# CITY PLANNING COMMISSION

APPLICATION: A. Negative Declaration  
B. Special Permit to Develop 24,400 ± sq. ft. Retail Shops  
C. Plan Review for Retail Shop Development

APPLC. NO. P84-291

ADDITION TO  
 POINT WEST  
 SHOPPING  
 CENTER

# SITE PLAN

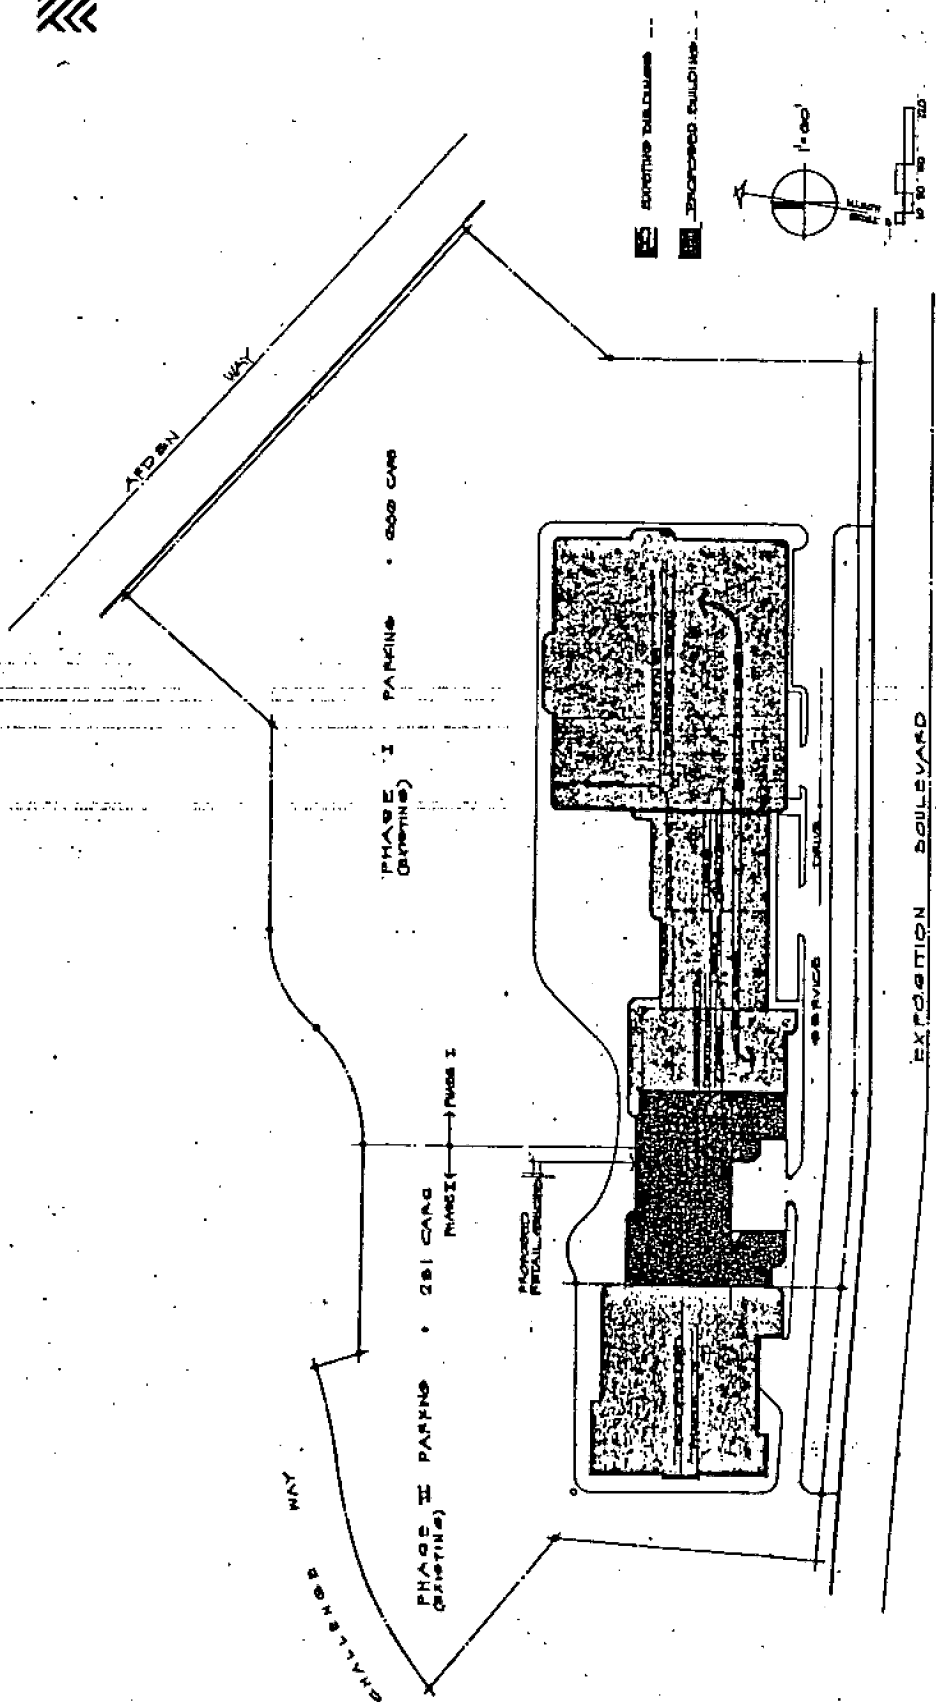
- C. The applicant's plan indicates that landscaping will be provided on the site. In an effort to ensure proper shading of the site and to allow for review of the landscaping plans, it is recommended that the landscaping plans be submitted to staff for review and approval prior to issuance of building permits.
- D. The plans have been reviewed by City Traffic Engineering, Building Inspection, Engineering, and the Point West Architectural Review Committee. They had no comments.

1. A sign program for the proposed structure shall be submitted to staff for review and approval and shall comply with the Point West PUD Guidelines.
2. A detailed landscaping and irrigation plan shall be submitted to staff for review and approval prior to issuance of building permits.

# ELEVATIONS

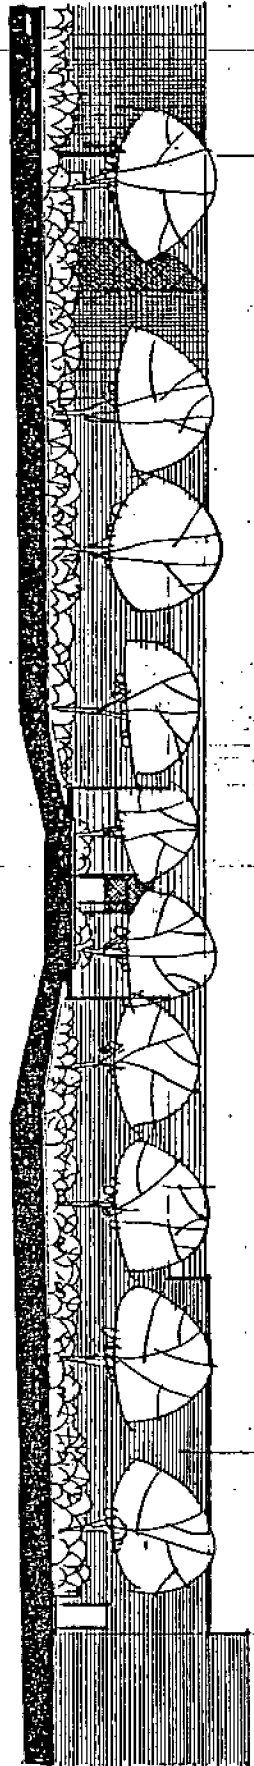
- B. The applicant's plans indicate that the design and materials of the proposed structure are compatible with the existing buildings.

In addition, since the structure is proposed for retail use, it is anticipated that individual shops will require signage. To ensure that the overall effect of these signs will comply with the Point West Development Guidelines and will also be compatible to the project design, a sign program shall be submitted to the staff for review and approval.
